ADDENDUM NO. 2

DATE OF ISSUANCE: March 21, 2023

PROJECT: 2023 Henryville Flooring Replacement
Phase 2 & Cafeteria Expansion
213 N. Ferguson. St.
Henryville, IN 47126

ARCHITECT'S PROJECT NO.: 21-47.007

6 Section
S-201 SCALE: 3/4"=1'-0"

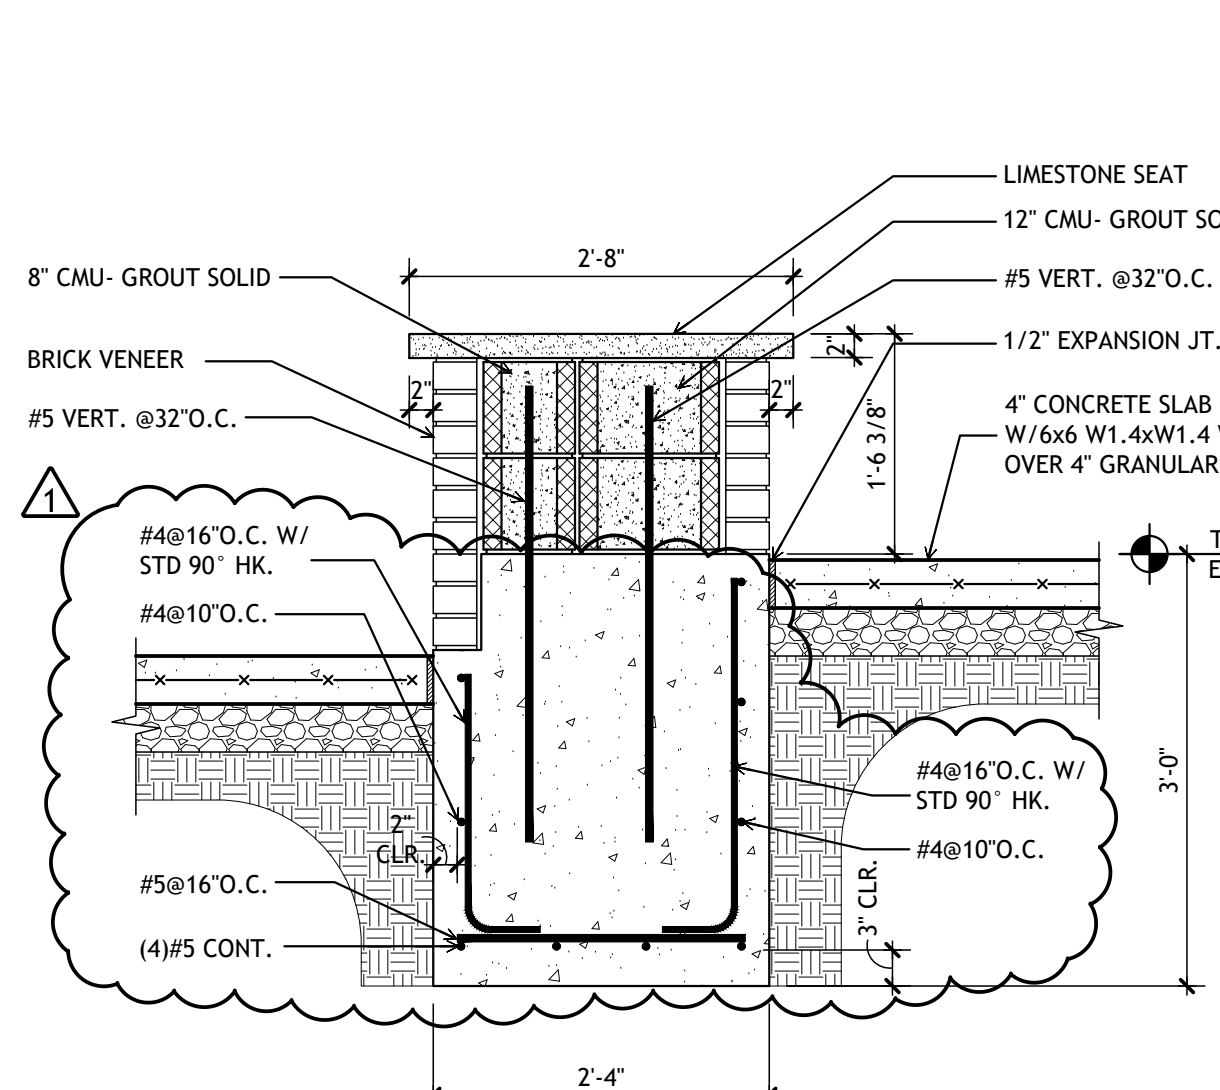
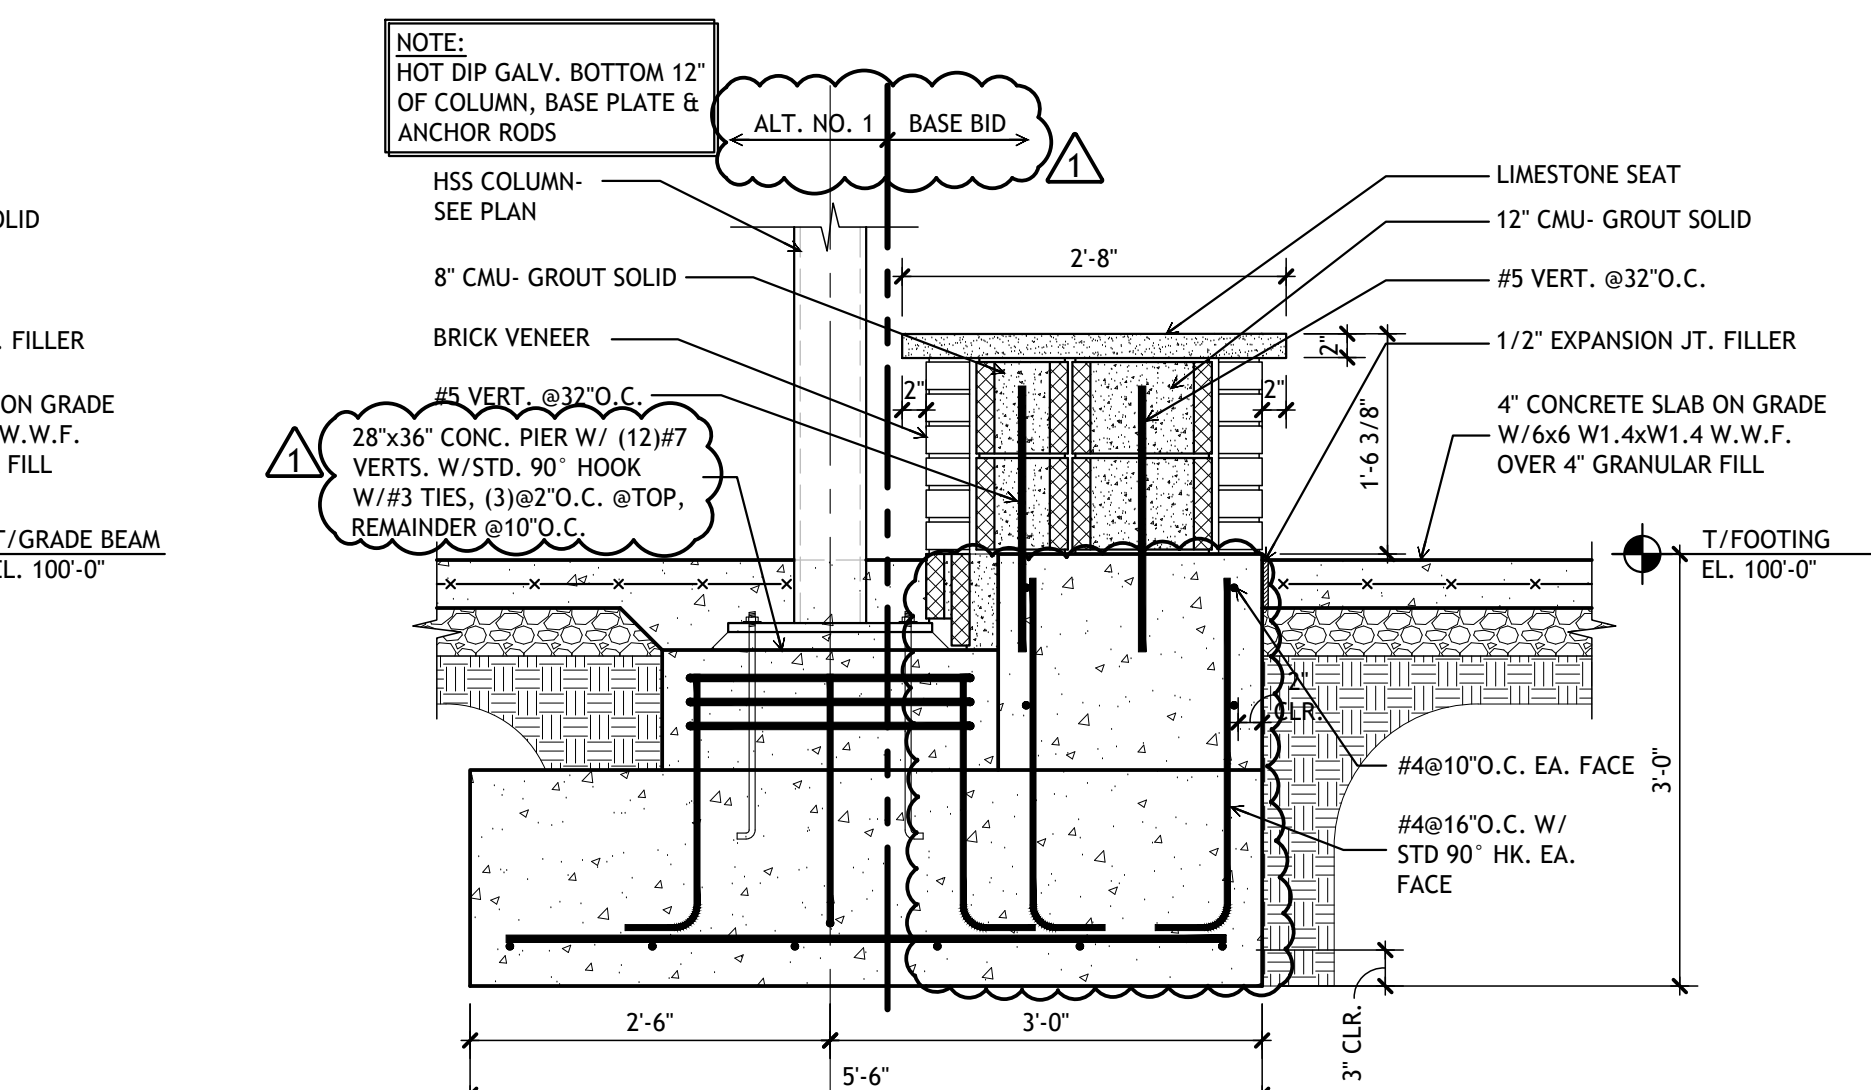
ADD-1 Item No. D-5 - Foundation Details

Refer to Sheet(s): S201 and S202

Replace with attached revised Drawings in their entirety; revisions have been clouded for reference.
